Access Compliance Report

Public Rights-of-Way

Intersection ID: 19971	Main Street: BURNLEY_RD	Cross Street: EMERYWOOD_DR	Location: E
ADA ID: CD8F6C791332	Ramp Type: PerpDiag	Initial Pass/Fail: Fail	Overall Compliance: No
		Severity Score: 22.5

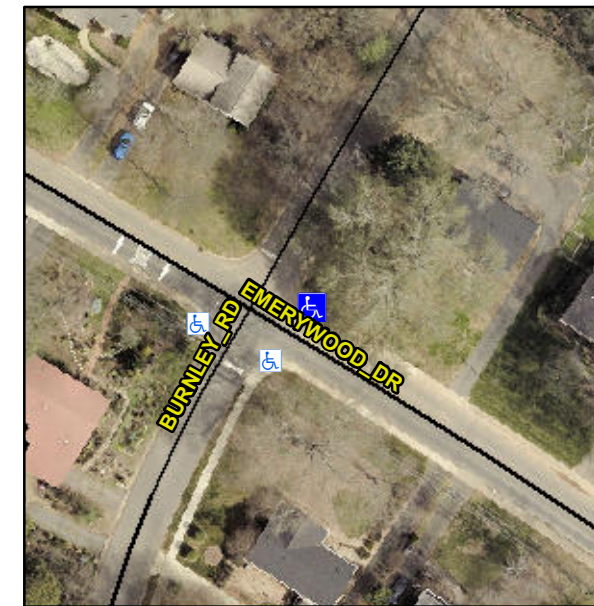
R304.5.1, R304.2.2, R304.5.3

Compliance	Description	Data	Compliance	Description	Data
N/A	Ramp Length (in)	59.0	No	Ramp Slope (%)	8.6
No	Ramp Width (in)	39.0	No	Ramp XSlope (%)	3.1
N/A	Flare Type LT	N/A	N/A	Flare Type RT	N/A
N/A	Flare Slope LT (%)	N/A	N/A	Flare Slope RT (%)	N/A
N/A	Flare Traversable LT?	N/A	N/A	Flare Traversable RT?	N/A
N/A	Landing Length (in)	N/A	N/A	DWS Provided?	N/A
N/A	Landing Width (in)	N/A	N/A	DWS Contrast?	N/A
N/A	Landing Slope (%)	N/A	N/A	DWS Length (in)	N/A
N/A	Landing X Slope (%)	N/A	N/A	DWS Full Width?	N/A
N/A	Landing Curb? (Y/N)	N/A	N/A	DWS Offset (in)	N/A
N/A	Shared Landing?	N/A			
N/A	Gutter Ponding?	N/A	N/A	Gutter Slope (%)	N/A
N/A	Gutter Lip Ht (in)	N/A	N/A	Gutter X Slope (%)	N/A
N/A	Painted X Walk1?	No	N/A	Painted X Walk2?	No
	X Walk 1 Direction	To NW		X Walk 2 Direction	To SW
N/A	X Walk 1 Width (in)	N/A	N/A	X Walk 2 Width (in)	N/A
	X Walk 1 Slope (%)	10.2		X Walk 2 Slope (%)	3.3
	X Walk 1 X Slope (%)	0.9		X Walk 2 X Slope (%)	6.7

Remove & Replace Curb Ramp With Two New Directional Ramps or Equivalent.
